PLANNING COMMISSION AGENDA

TO: Planning Commission
FROM: Marcia Strange, Director of Community Development
DATE: March 12, 2025
SUBJECT: 210 WINSTON DRIVE HOTEL - INTRODUCTION

PRELIMINARY SITE PLAN
HOME 2 SUITES BY HILTON
MARENGO HOTELS, LLC
PROJECT LOCATION:
UNIT 5 MARSHALL PROFESSIONAL PARK SITE CONDOMINIUM
210 WINSTON DRIVE, MARSHALL, MI 49068
SECTION 27, T2S-R6W, CITY OF MARSHALL, CALHOUN CO., MI

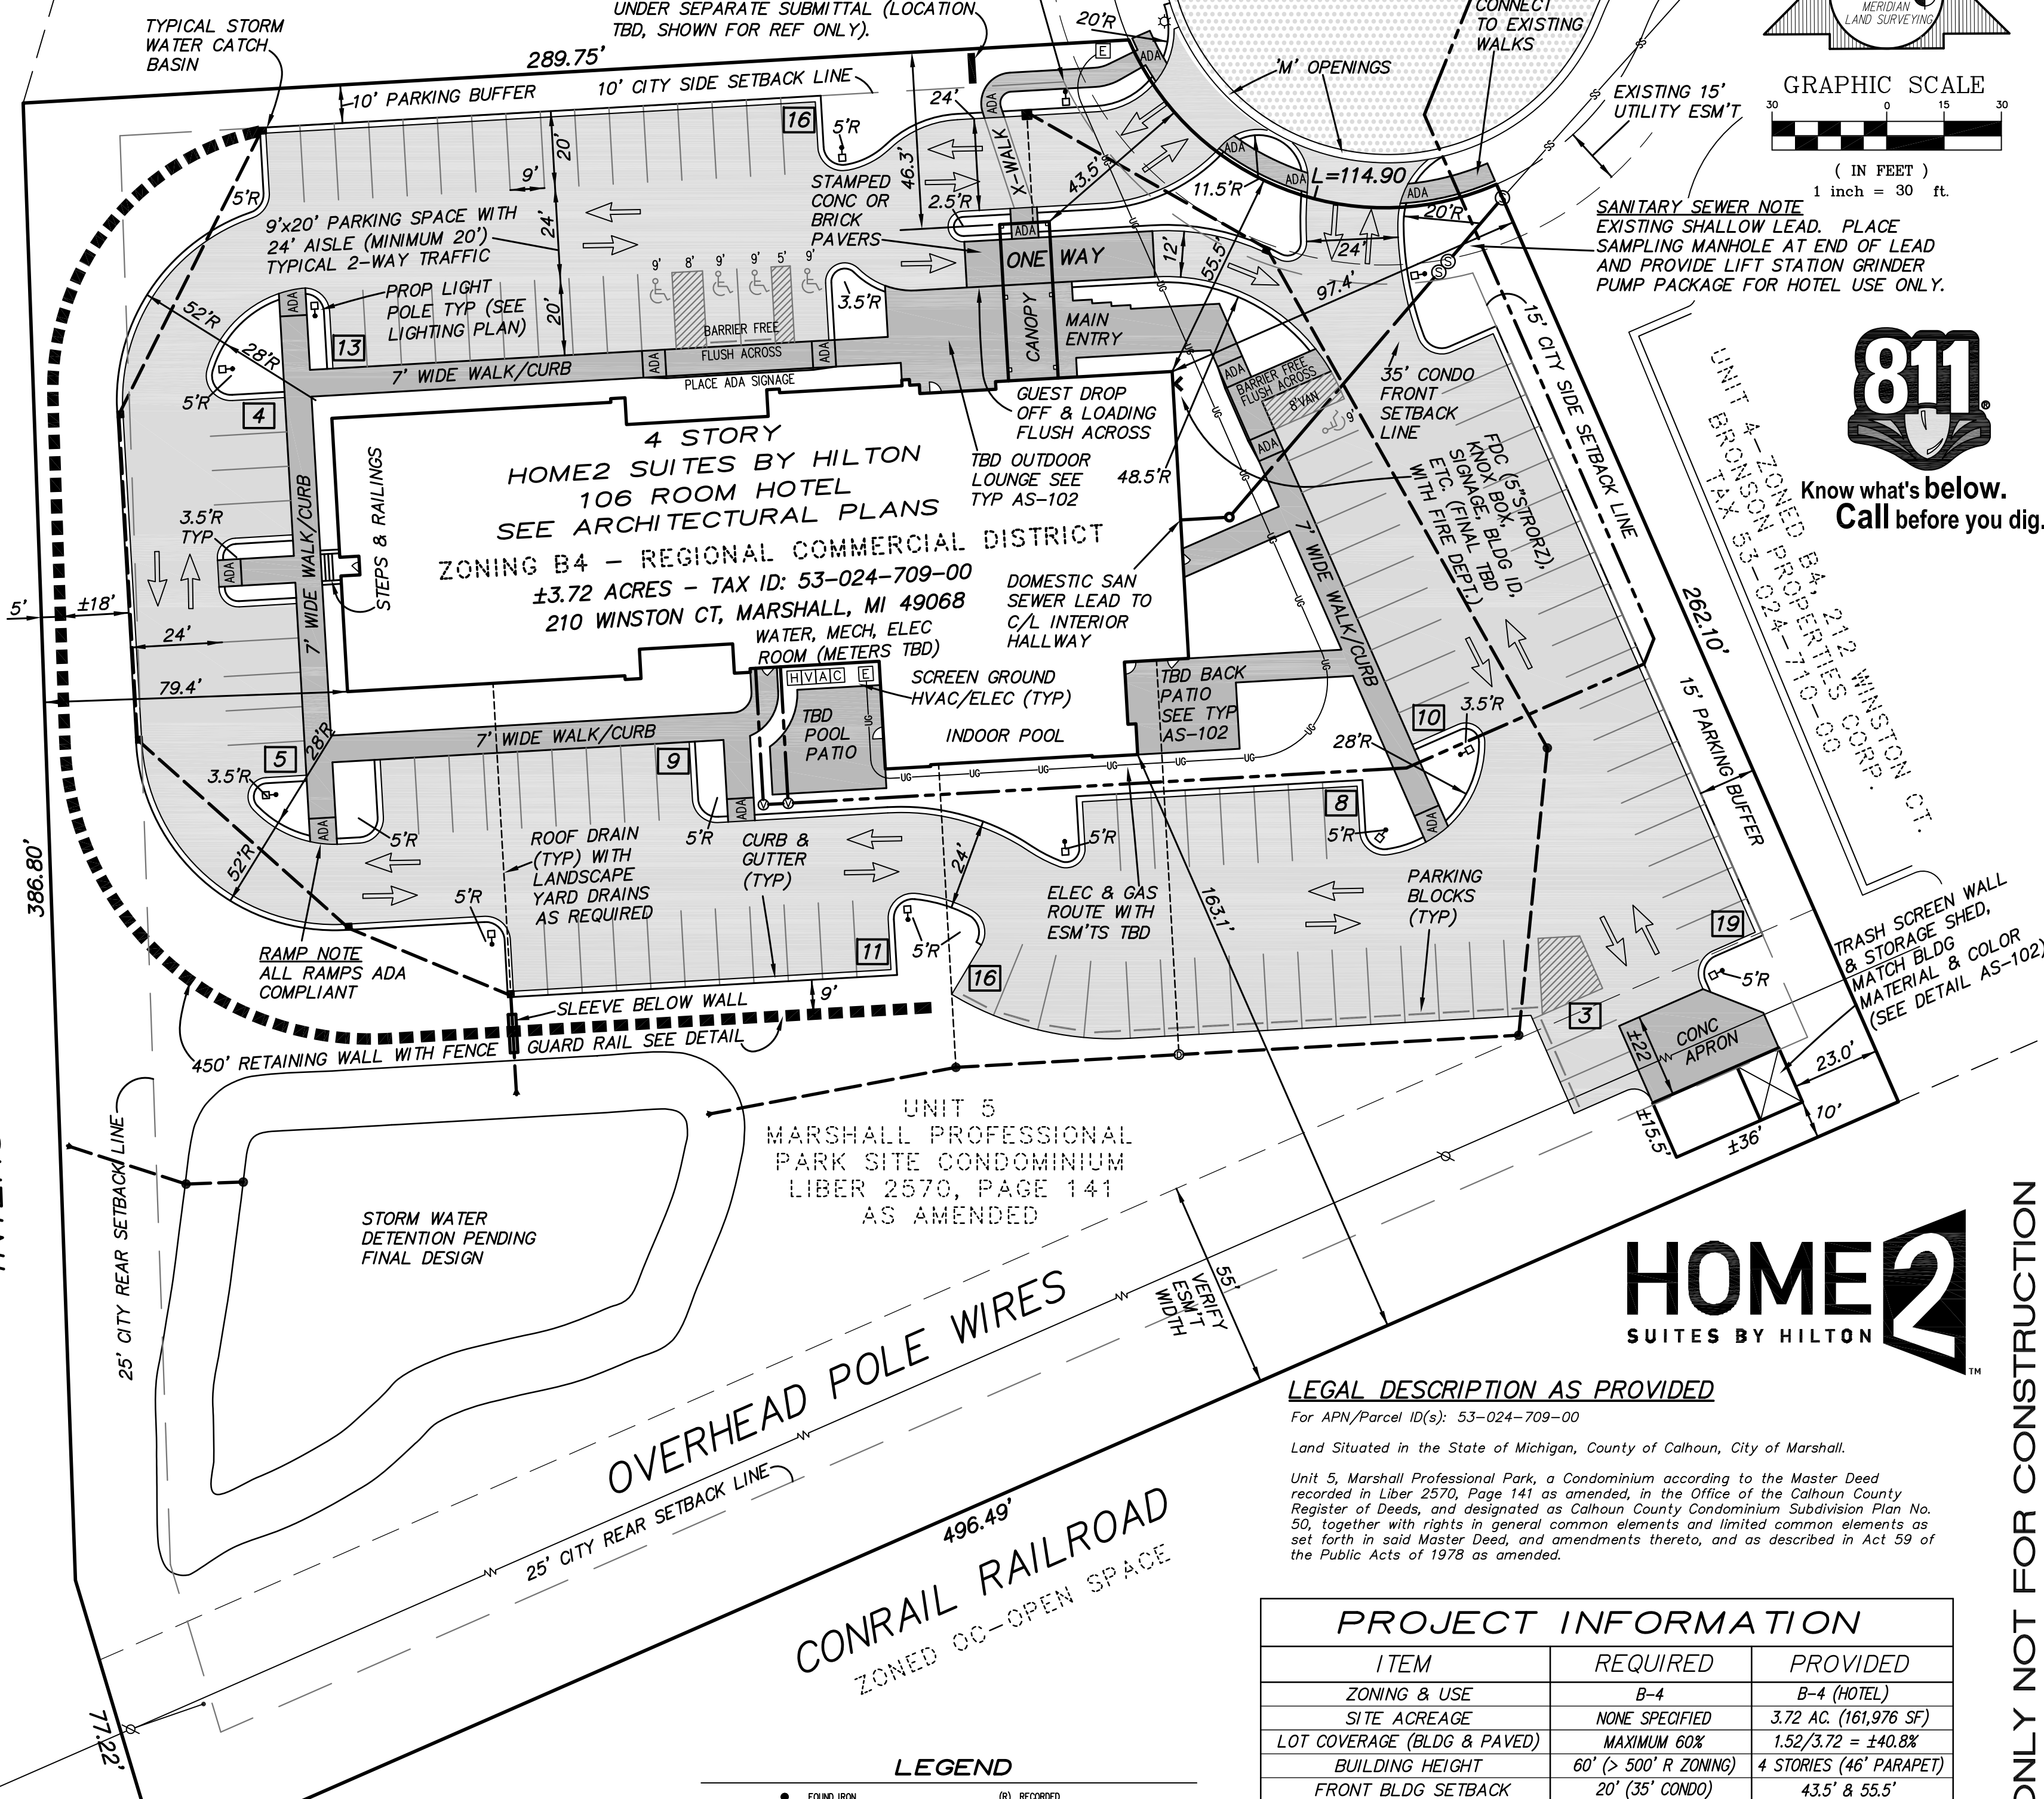
Screening of HVAC and electrical equipment is required. Additional detail is requested of any ground-mounted equipment to confirm extents and type of screening.

Staff has recommended the designers reach out to the Railroad regarding possible lighting requirements and have asked they provide information regarding communication and any subsequent requirements discovered.

LANEDSCAPING PLAN

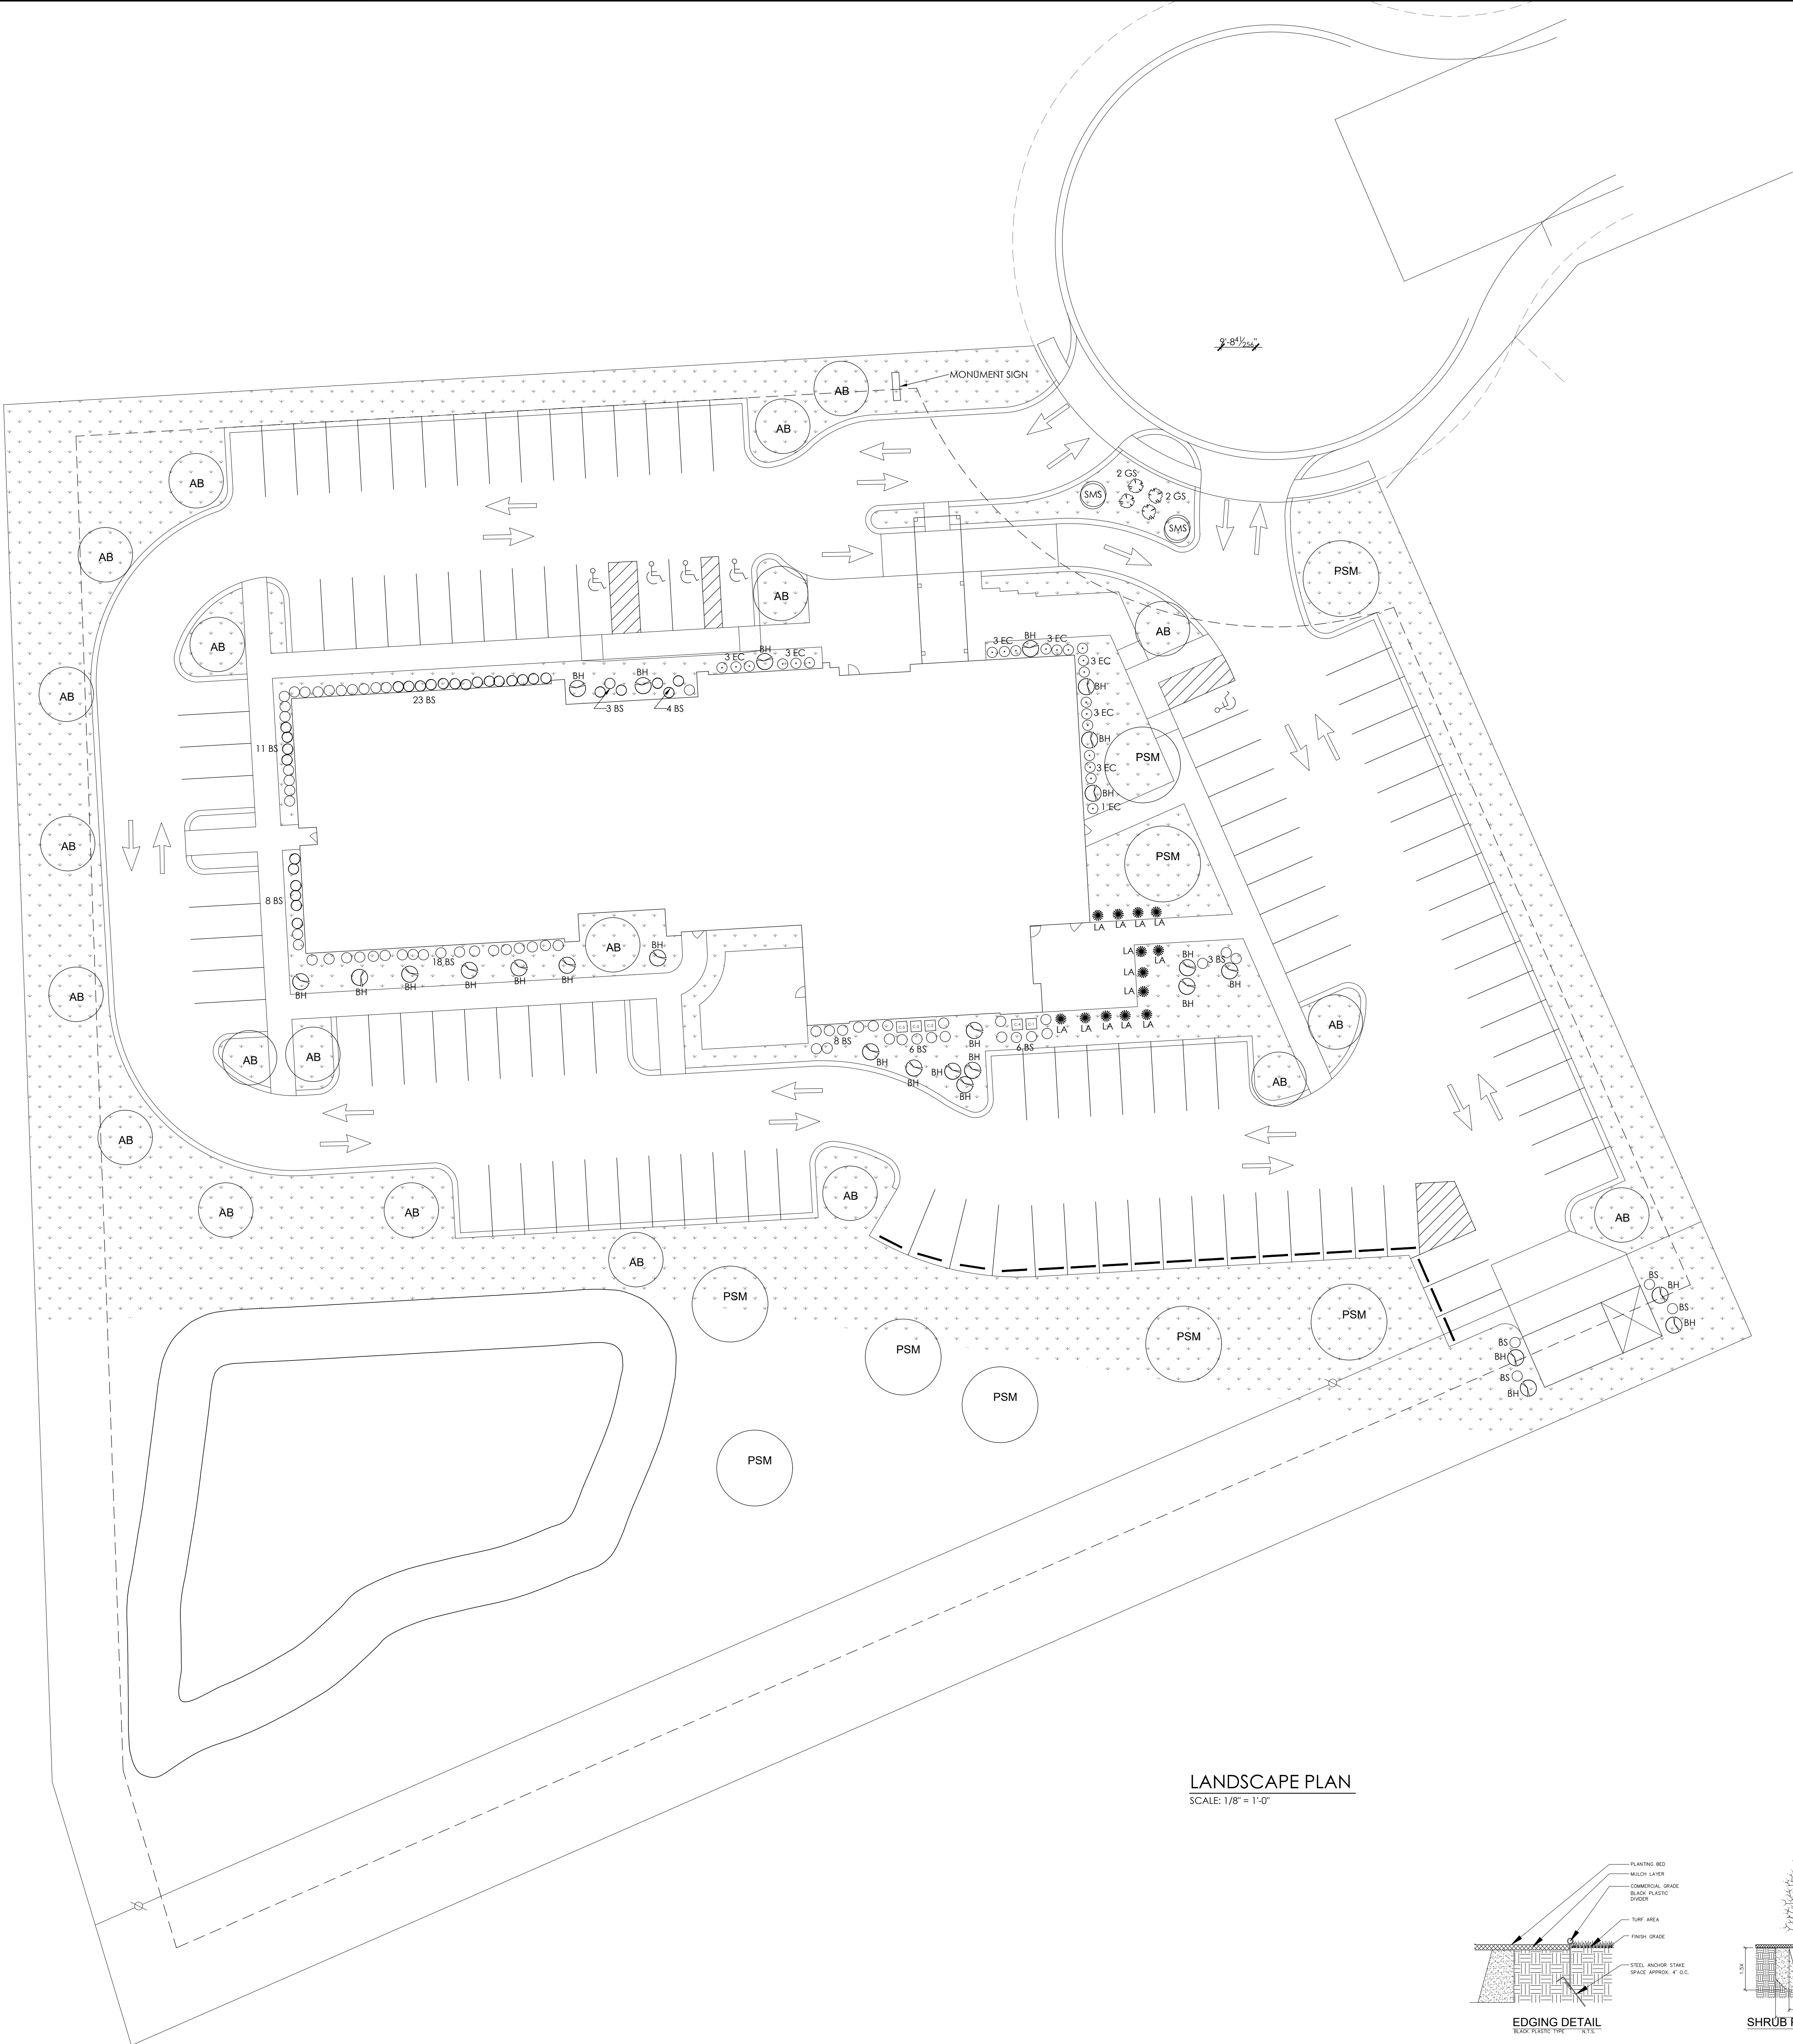
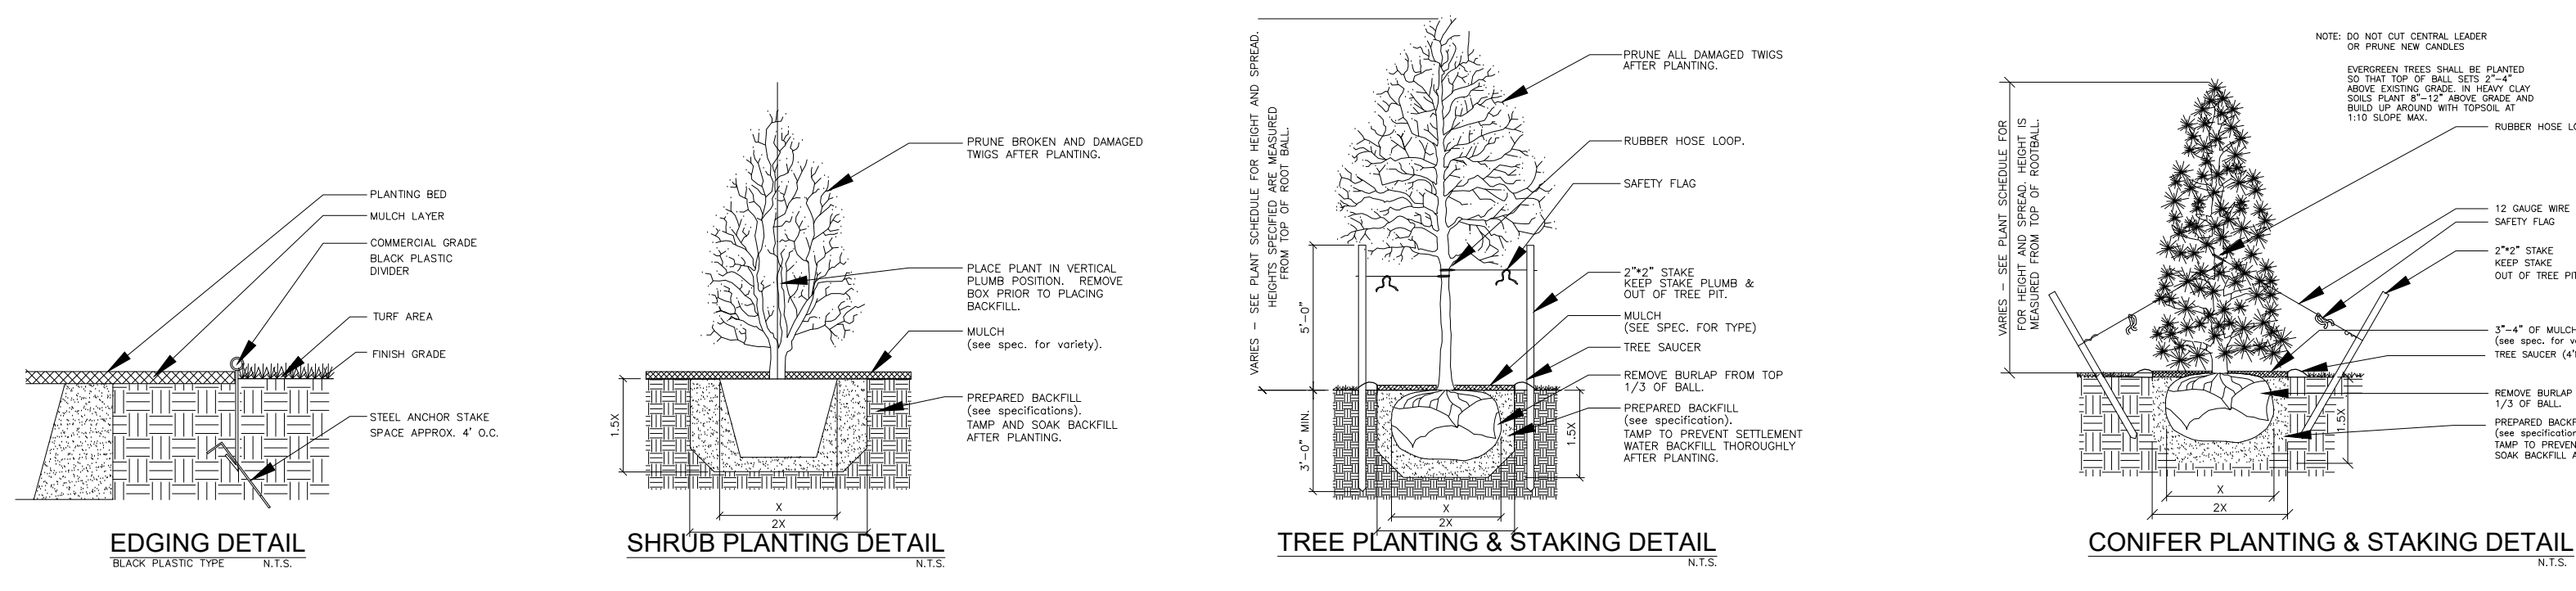
The landscape plan is not sealed and is required to be sealed by a Landscape Architect prior to approval by the Planning Commission.
